Planning Commission Regular Meeting | 5:30 PM

Wednesday, April 29, 2026

A. 0126 Miles End Lane - New Single Family Residence

Final Plan Review for New Home

PROJECT NO.
23005
Designer:
PAH
Checker:
BUJ
Date:
1/24/26

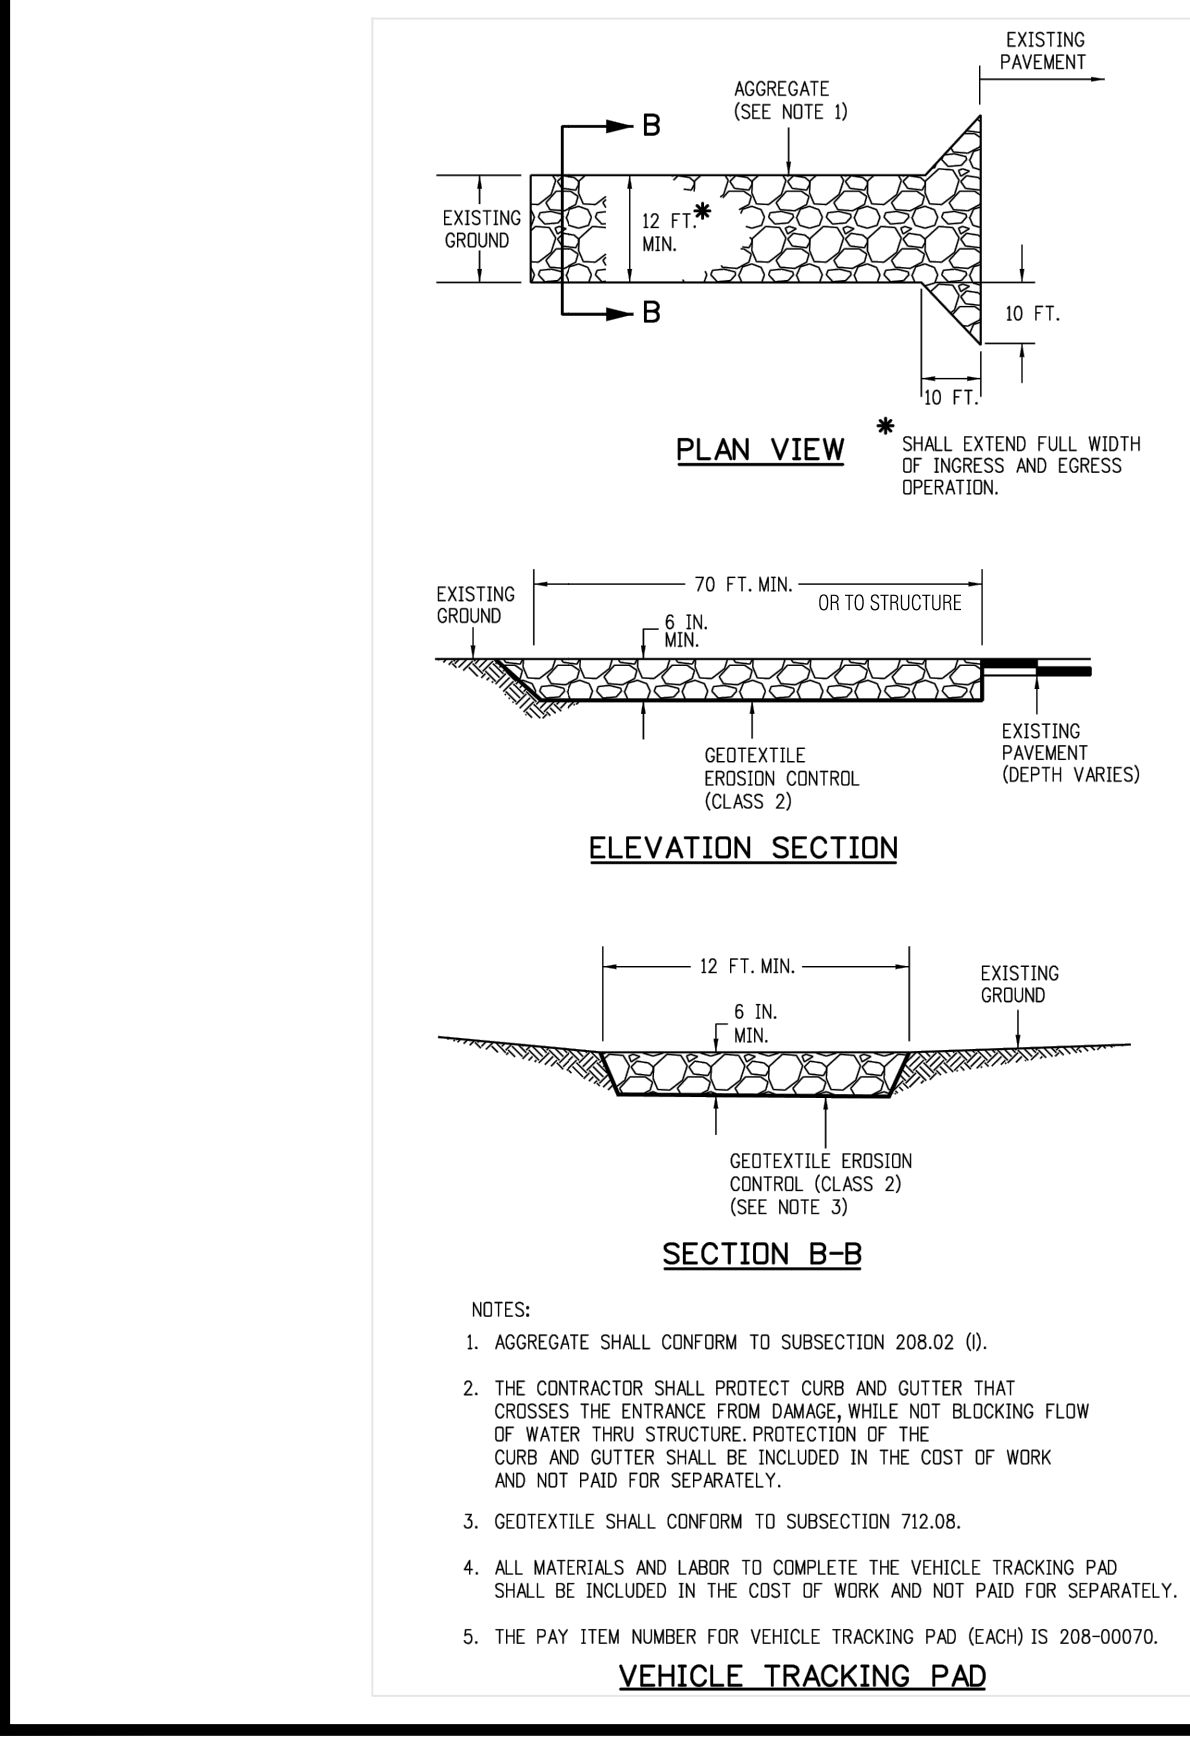
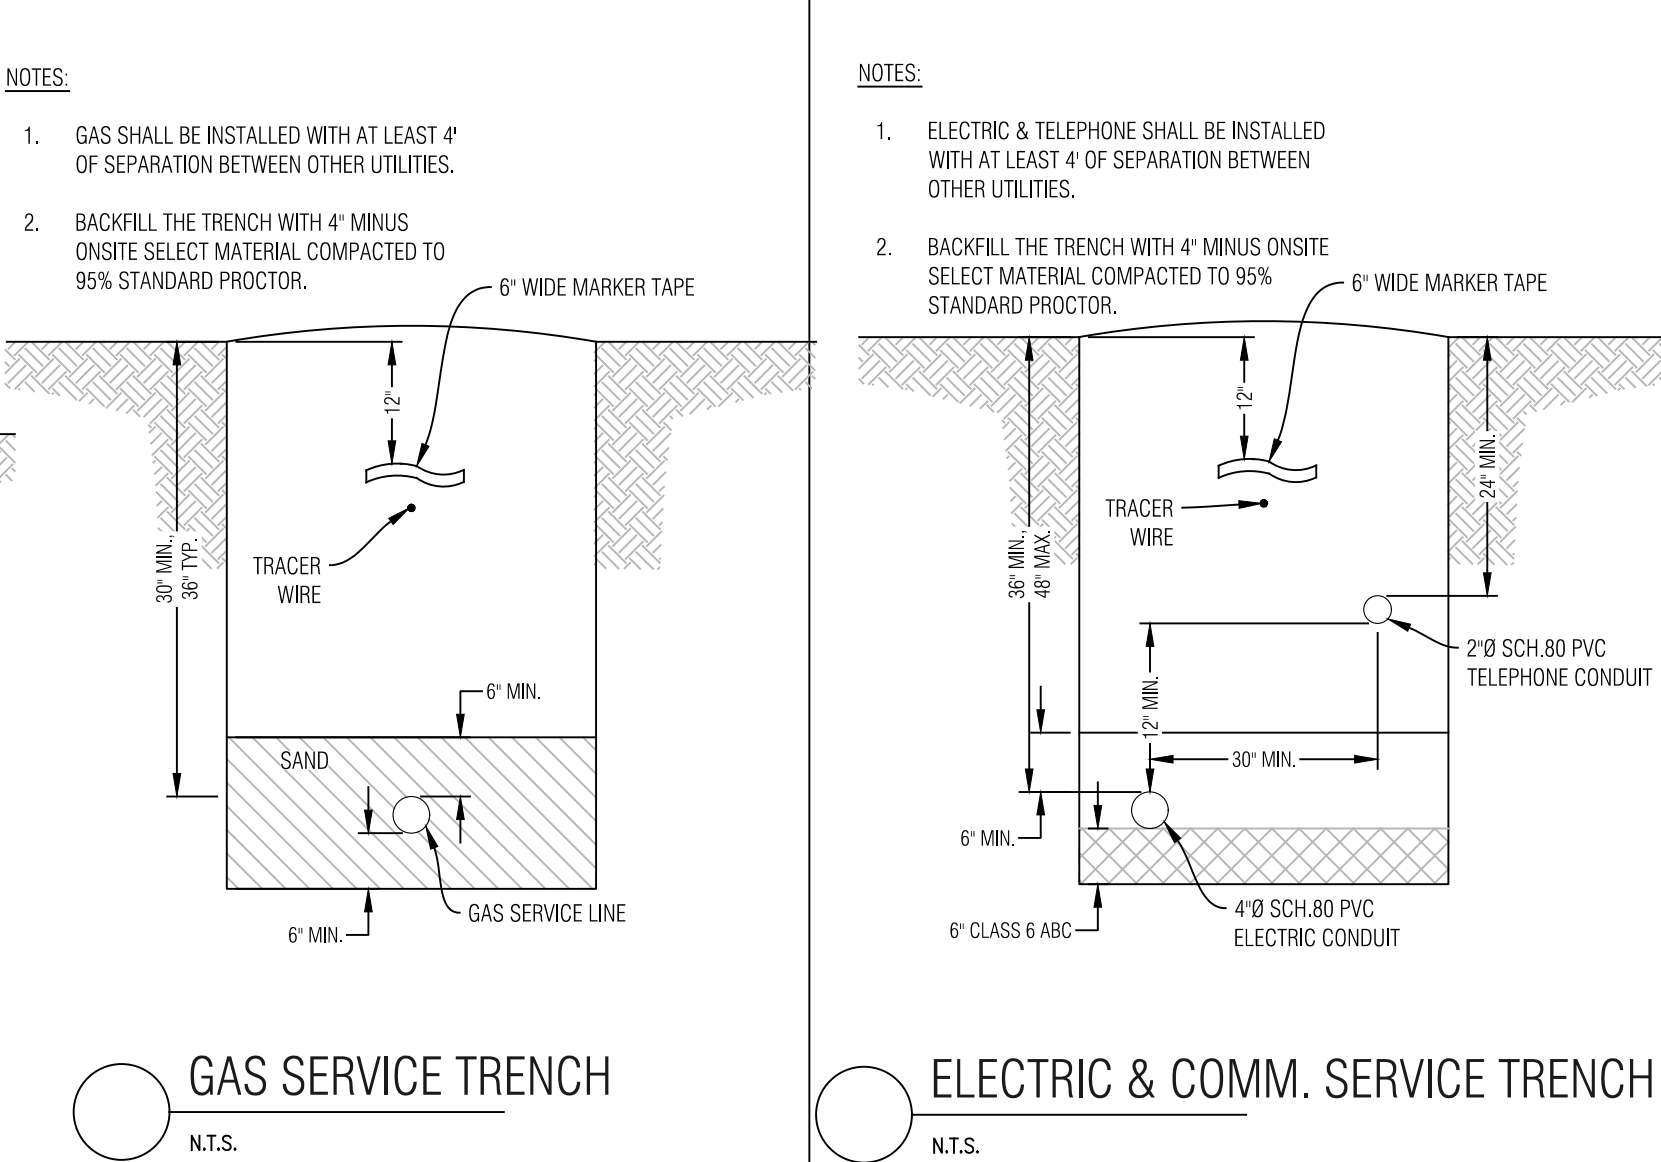
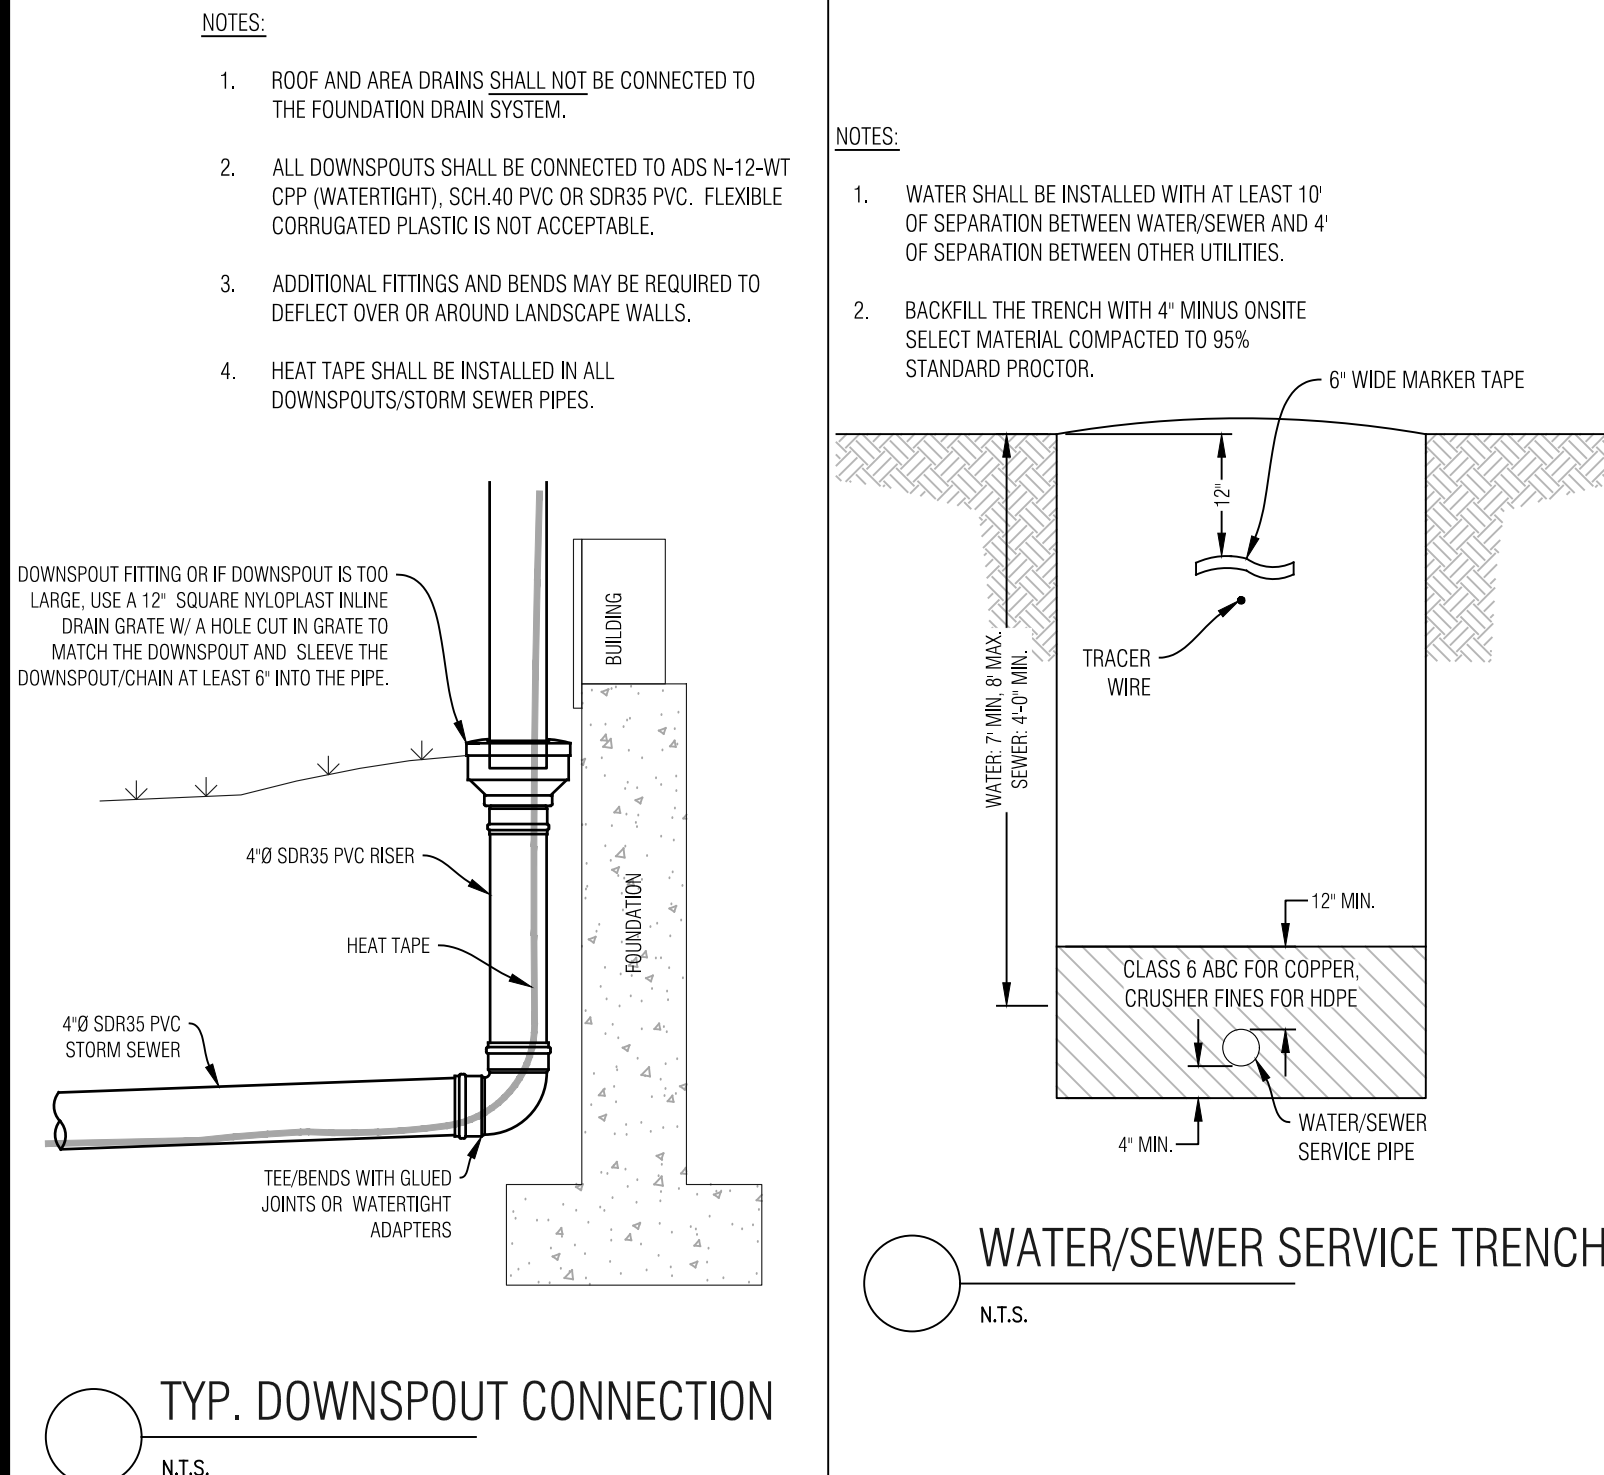
Sheet C1 of the Plans "*Lot 13, Minturn North PUD; Site Grading and Drainage Plan*" prepared February 4, 2026, by Boundaries Unlimited presents the proposed site grading and drainage. The Plan fulfills Grading and Drainage Plan requirements.

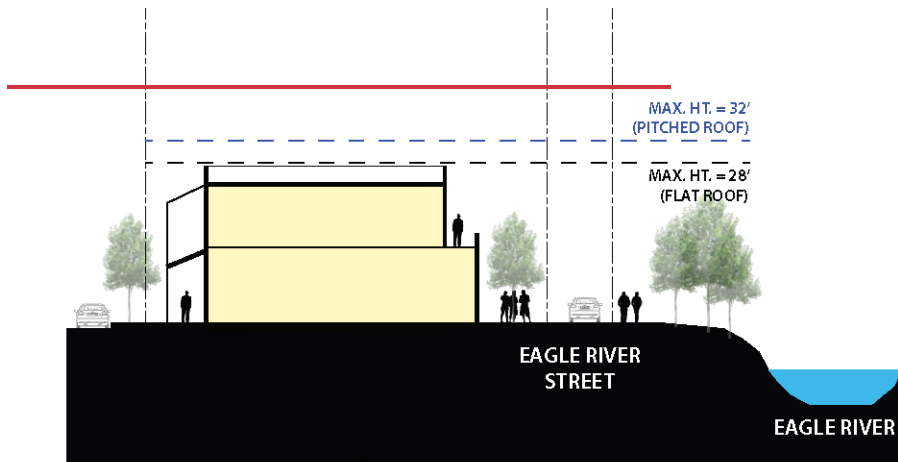
Commented [MF21]: NOTE TO PLANNING COMMISSION:
Given that the former 100-Block building height standards no longer apply, staff is recommending that this language be deleted to avoid confusion.

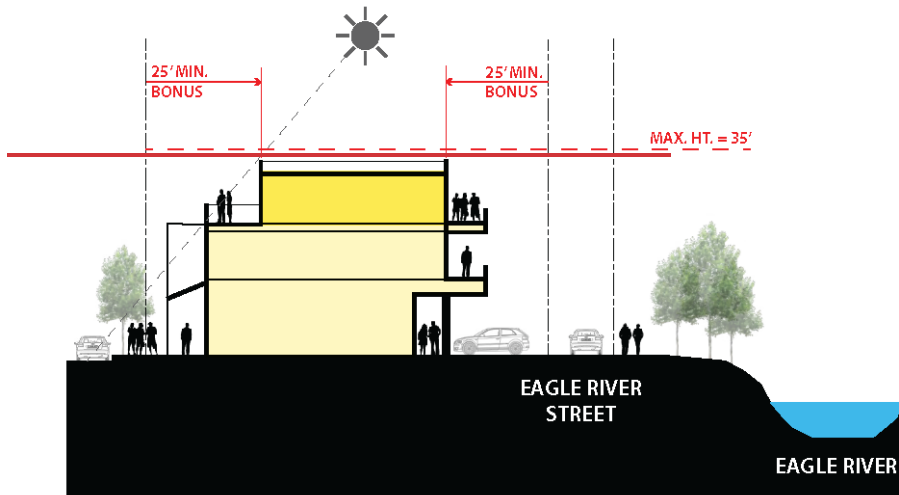
Commented [MF23]: NOTE TO PLANNING COMMISSION:
Staff is recommending that the 100-Block Incentive Floor requirements (refer to [Sec. 16-2-65](#) of the existing Code) be incorporated with the Dimensional Standards in Article 2: Zoning Regulations.

Staff will work to incorporate this language and illustration with the Dimensional Standards in Article 2: Zoning Regulations.
